Subject: CHIRP NOISE FROM REAR SHOCK ABSORBERS	Bulletin No: 02-003/14
	Last Issued: 10/23/2014

BULLETIN NOTE

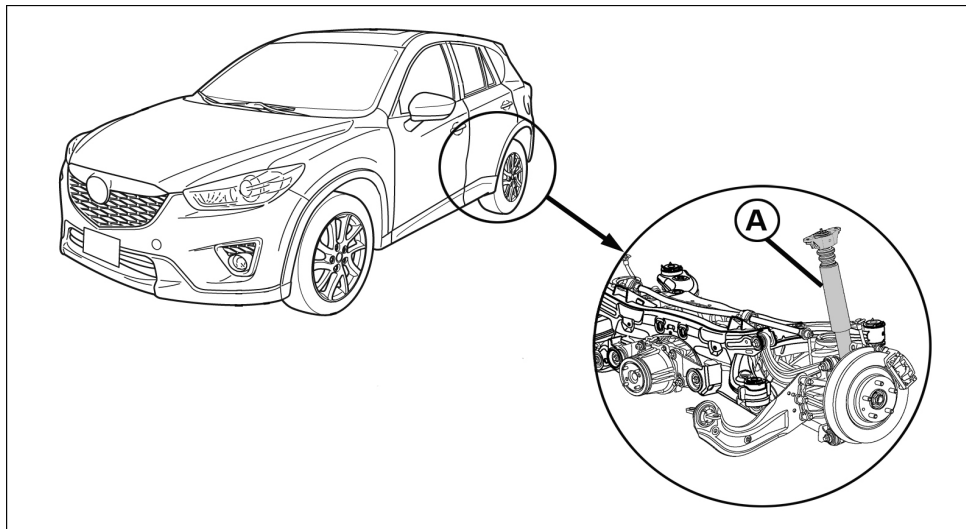
Some vehicles may exhibit a chirp noise from the rear shock absorbers (A) when driving on a rough road or passing over a speed bump. Visual inspection of the shock absorbers show no external damage or oil leakage.

1. Verify customer concern.
2. Replace the rear shock absorber. Refer to MS3 online or Workshop Manual (section 02-14 REAR SHOCK ABSORBER REMOVAL/INSTALLATION).
